### 1 Products affected

### 2 Type of change

Actuator dimensions have changed, see table below

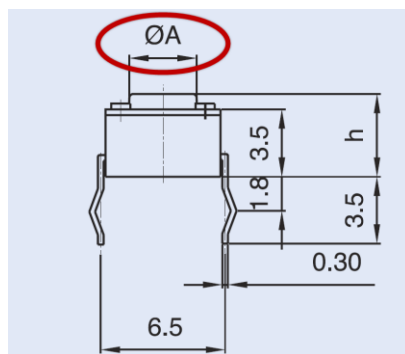
Part no.	Dimension A old [mm]	Dimension A new [mm]
<b>1301.9303</b>	Ø 3.2	Ø 3.3
<b>1301.9305</b>	Ø 3.1	Ø 3.3
<b>1301.9307</b>	Ø 3.0	Ø 3.4

Tolerance +/- 0.1

Form: Yes, see chapter 3  
Fit: Yes, see chapter 3  
Function: No influence  
Production Site: No influence
